Discussion of New State Machines and Specifications for Transport of Time Sync in 802.1AS using 802.11 FTM

IEEE 802.1 TSN TG
2016.05.14

□ This presentation addresses comments #77 and #79 against 802.1AS-Rev/D2.0

Comment #79 - 3

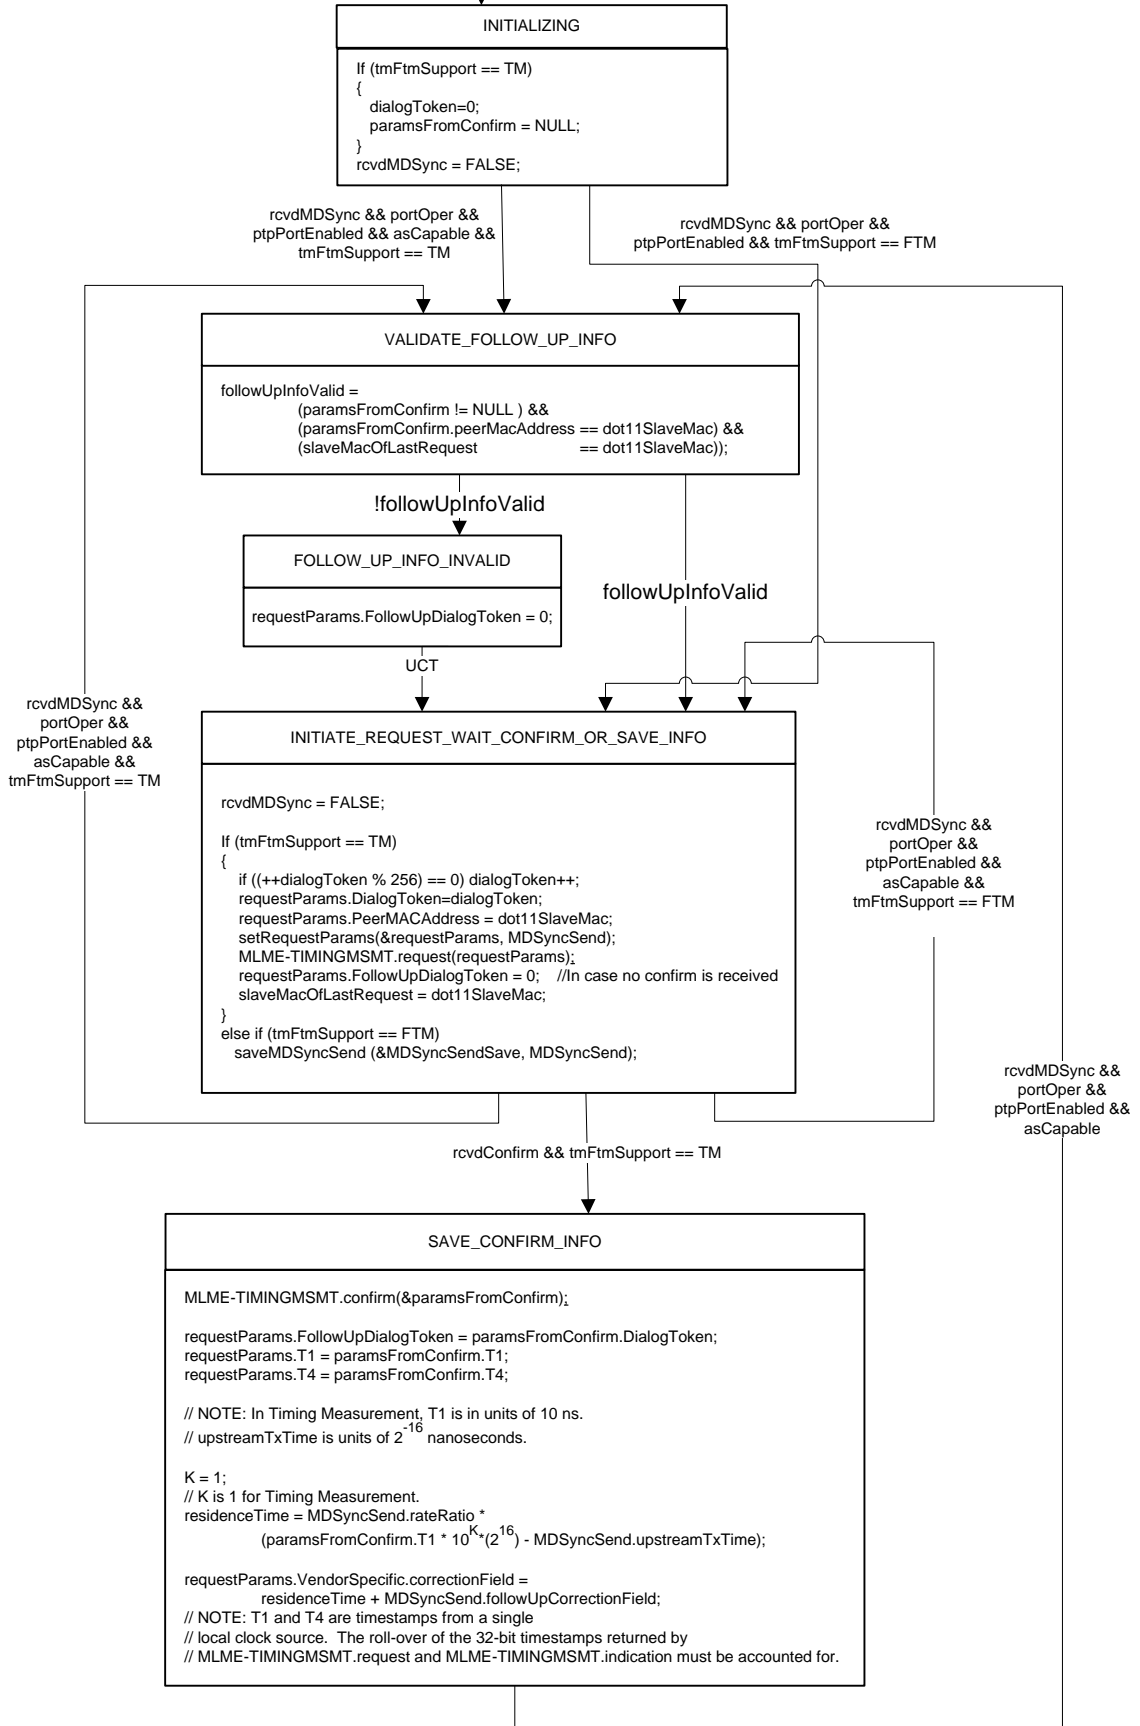
□ To accomplish the above with only changes to the MD layer state machines, we will do the following for the slave state machine

- With the above approach for the slave state machine, the master state machine must be de-coupled into 2 state machines:
 - (1) Receipt and storing of time synch information from upstream
 - (2) Receipt of initial FTM request and sending of FTM frames to the slave
- Master state machine (1) will be constructed by modifying the existing master state machine
- Master state machine (2) is a new state machine, though much existing code can be re-used.

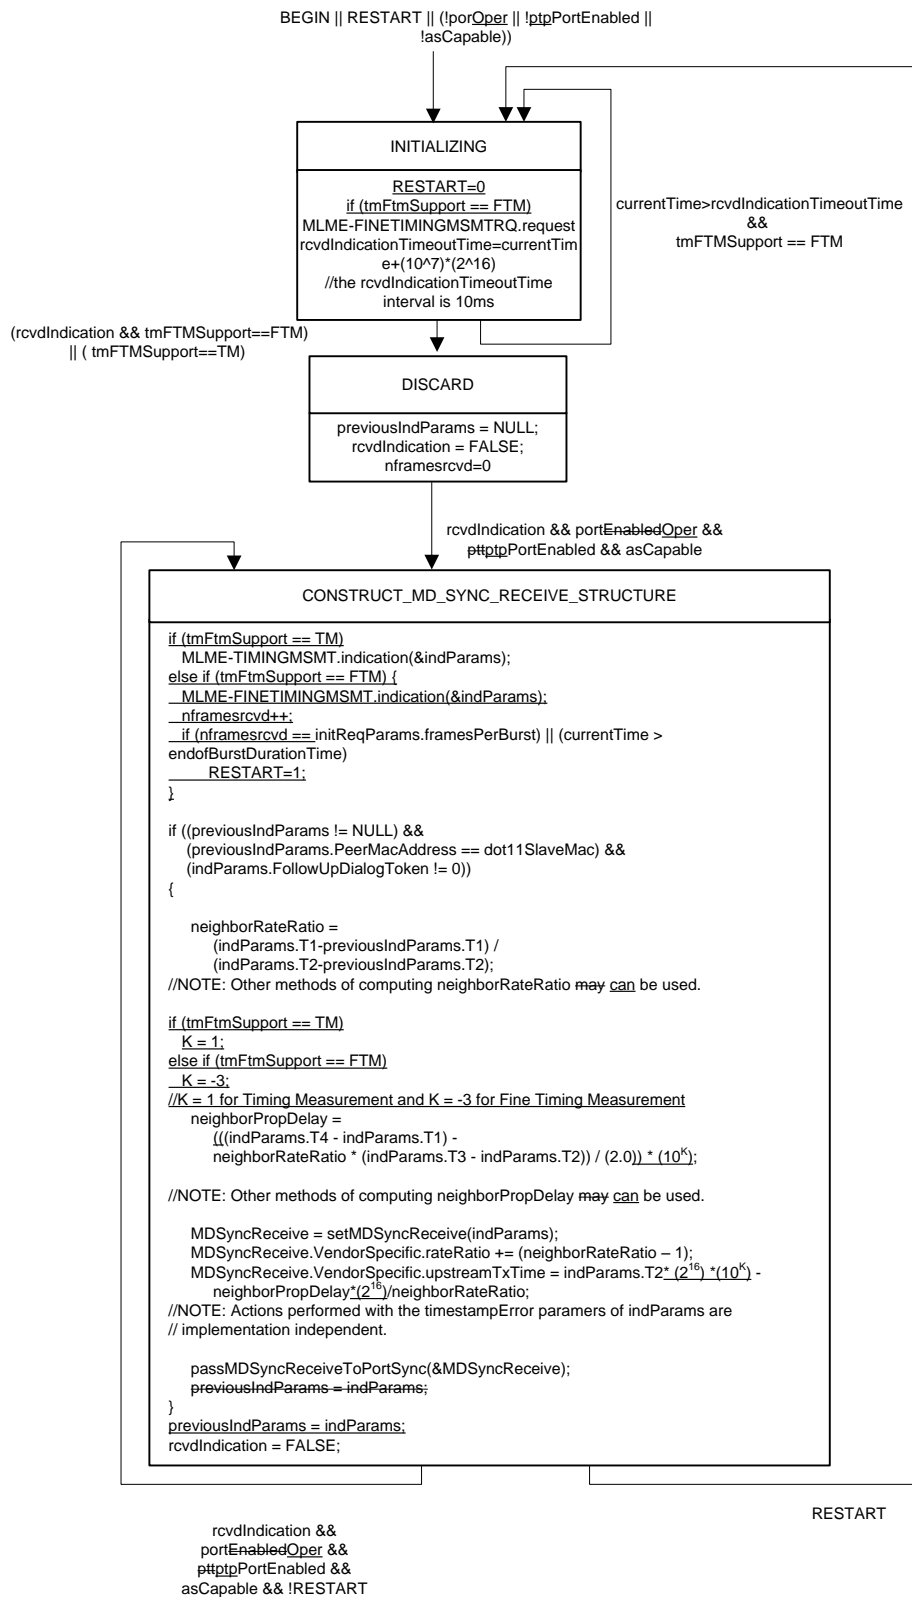
□ Initial drafts for the revised state machines are on the following slides
